### ADDENDUM TWO

Project: Cleveland St. Streetscape Phase III & Festival Core

Date:	March 4, 2021
Project No.	<b>Cleveland Street Streetscape Phase III, 16-0003 EN &amp; 19-0026-EN</b>
To:	Catherine Corcoran, RLA
From:	Christina M. Newcomb, PE
Subject:	<b>RESPONSES TO CONTRACTOR'S QUESTIONS – PRE-BIDDING PHASE</b>

1 DS-1-35 BAFFEL BOX DETAIL  
457 NTS

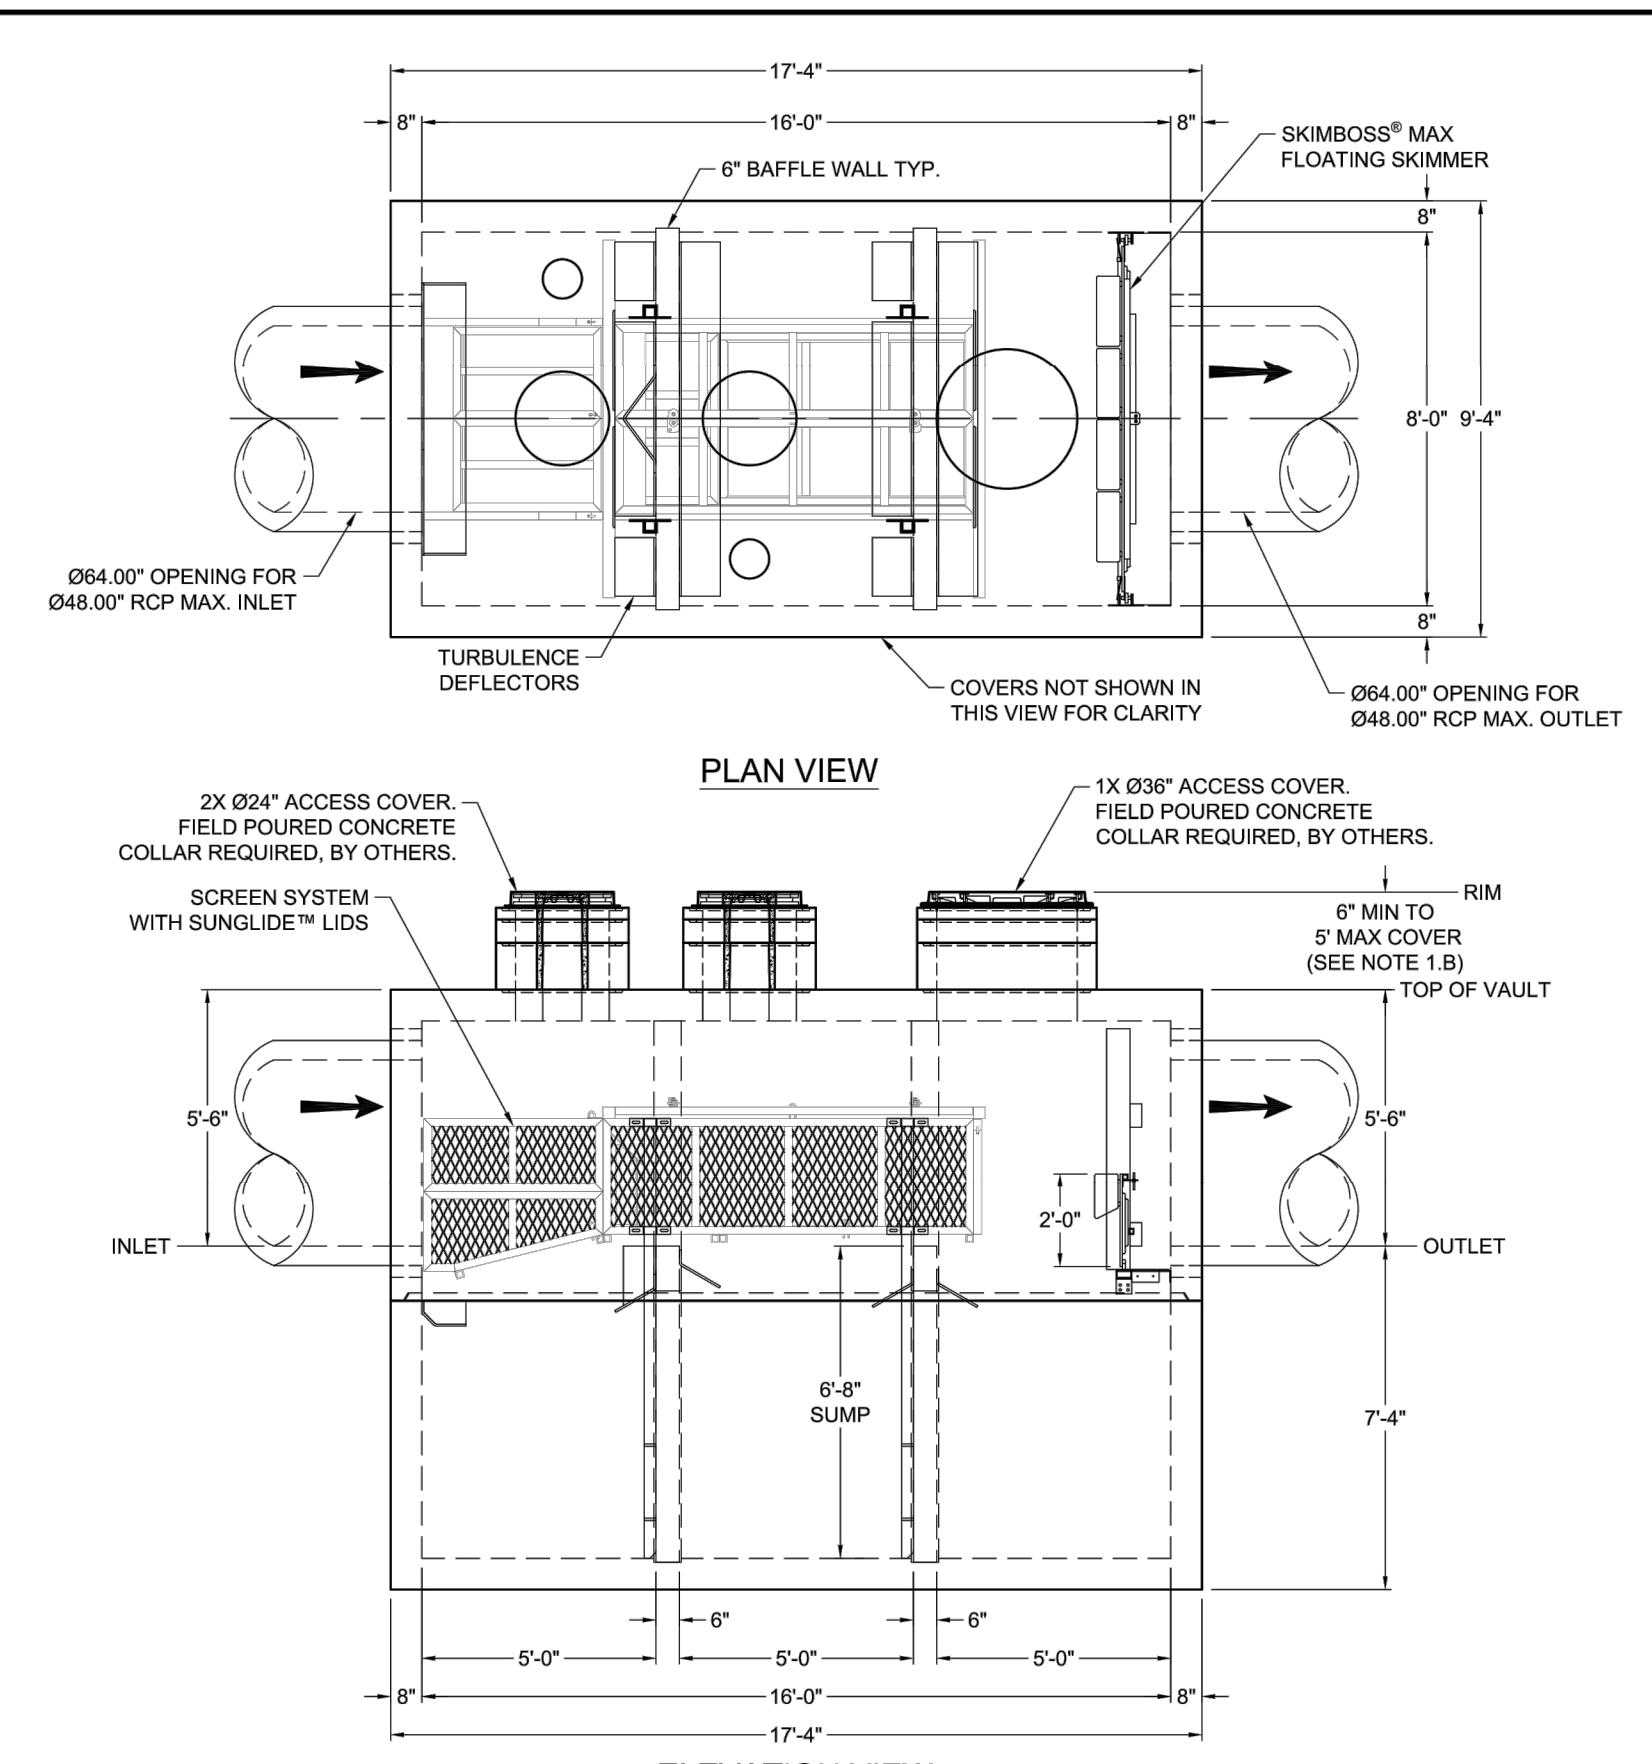
- b. Sub-set of sheets labelled on Cover Sheet 000 as sheets "460-468, Drainage Details" contains sheets 460 to 465, then (unlisted) sheets 456 Drainage Details, 457 Drainage Details, and 457 Baffle Box Box Details, which do appear to belong to that set.

***Response: See response above.***

DWG NAME:	FIELD BOOK:	SURVEYED BY:	SCALE:
A181093.02			VERT. N/A
CONTRACT NO.:	DATE DRAWN:	DRAWN BY:	
16-0003-EN	02-01-2020	DOD	
JOB NO.:	DESIGNED BY:	CHECKED BY:	SHEET NO.:
A181093.02	TAF	RF	921
APPROVED BY:

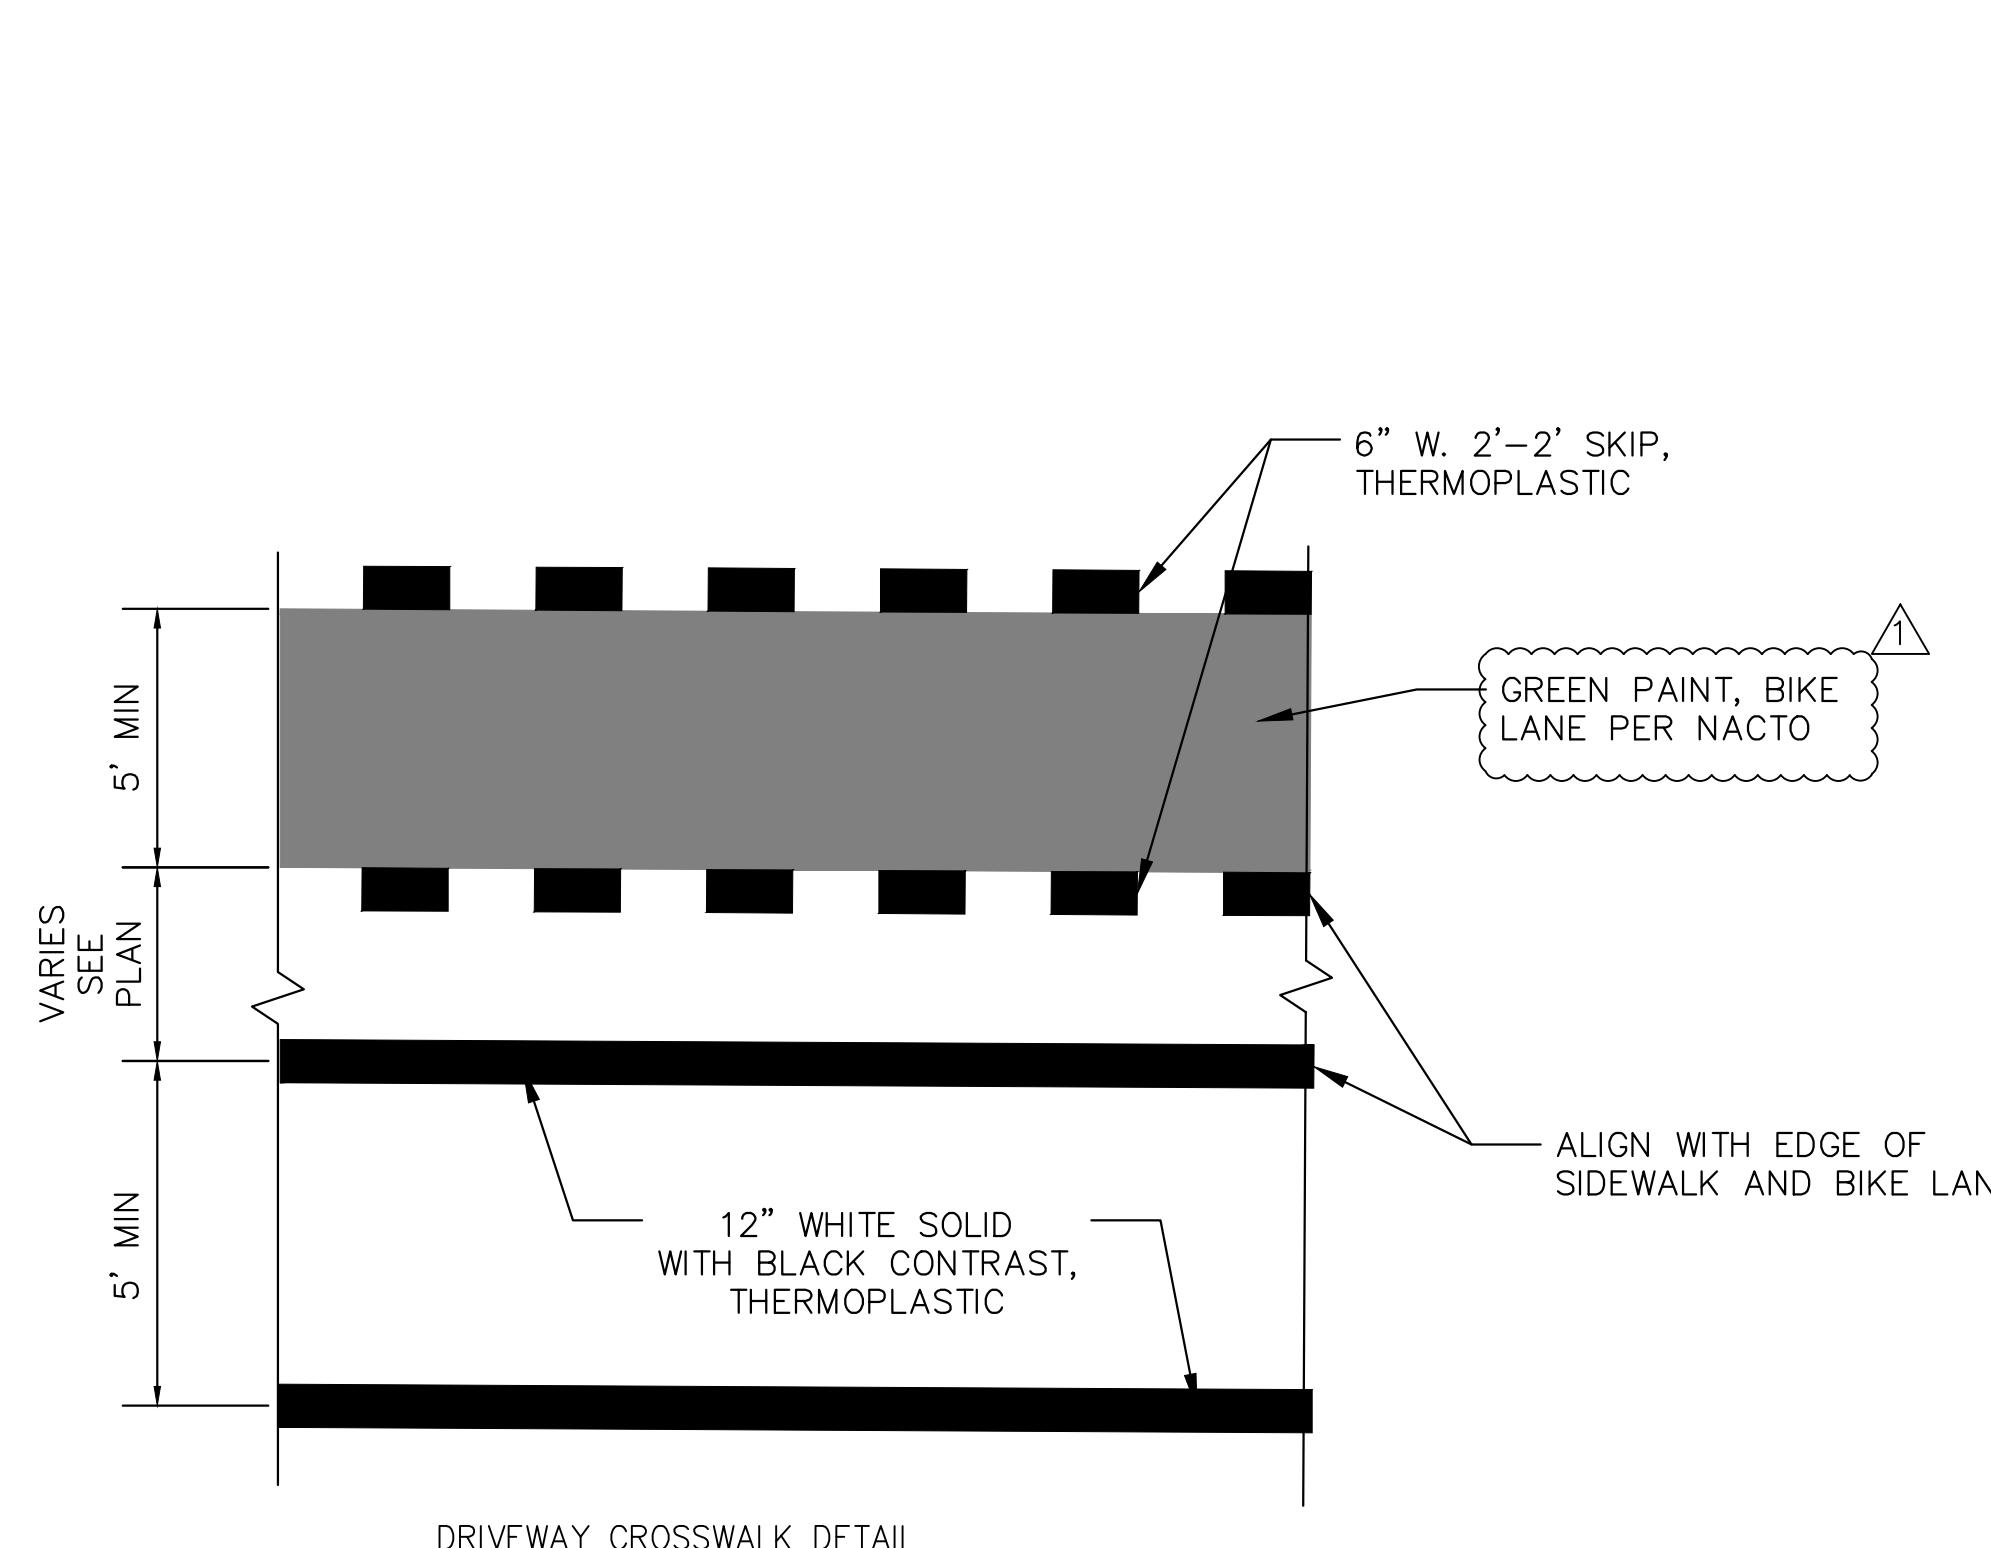
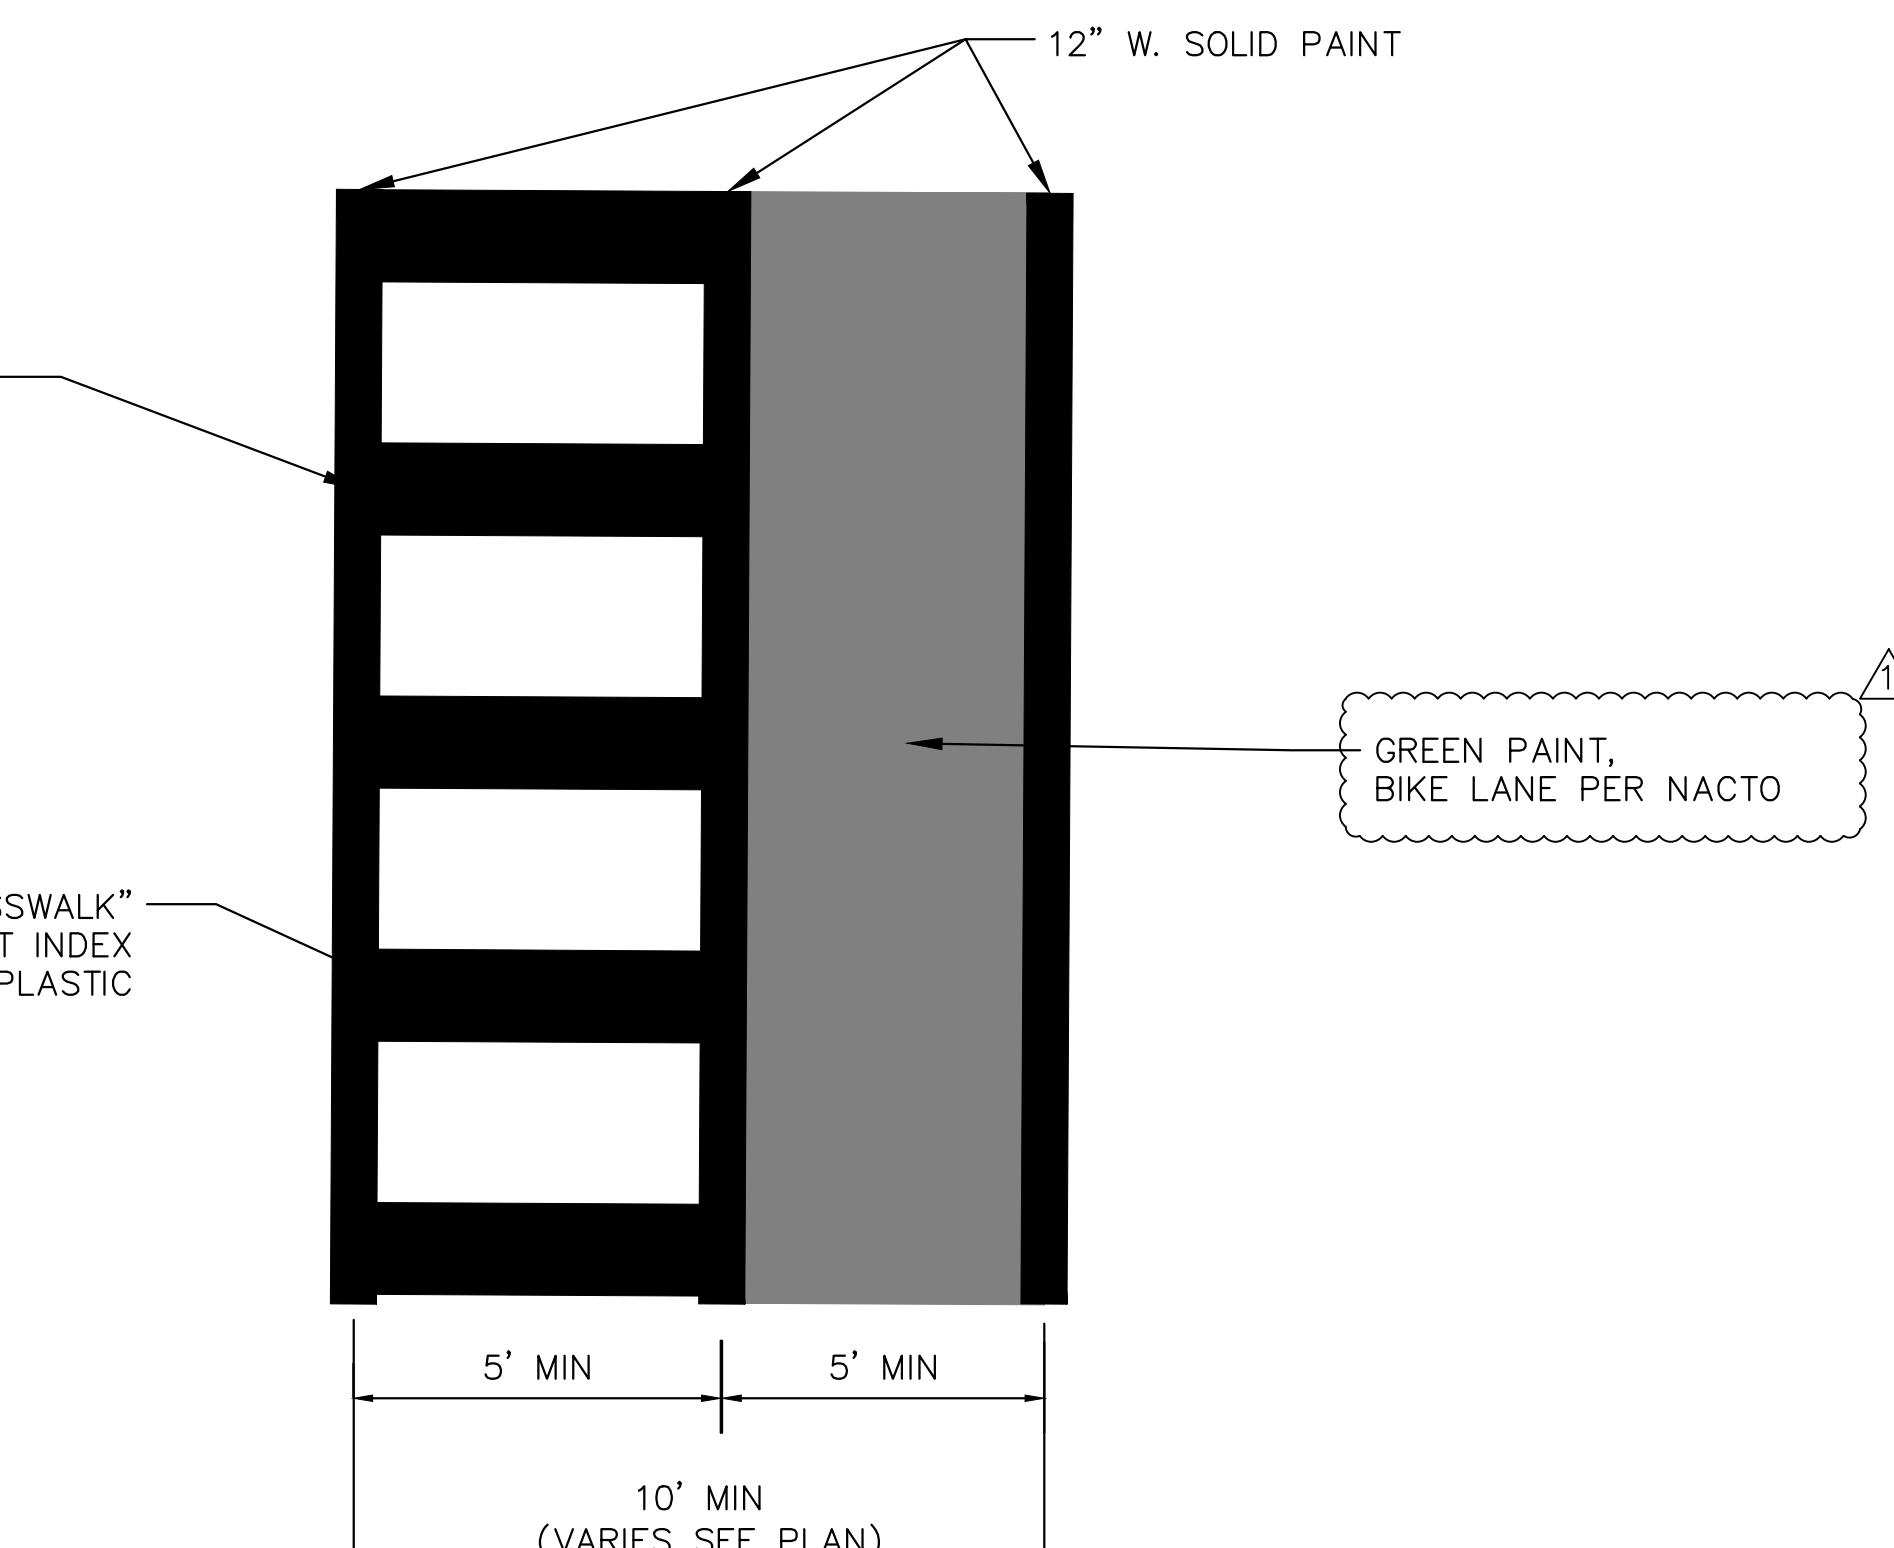
6. Pay item 3001 for patterned pavement vehicular areas, green bike lane is referred to on the SP drawings as green paint. Please clarify if any pattern is required. Please clarify is the product is paint, thermoplastic, or other product and if a specific manufacture is desired.

***Response: The pavement markings shall be paint, per the detail on sheet 921. Pay Item description will be updated***
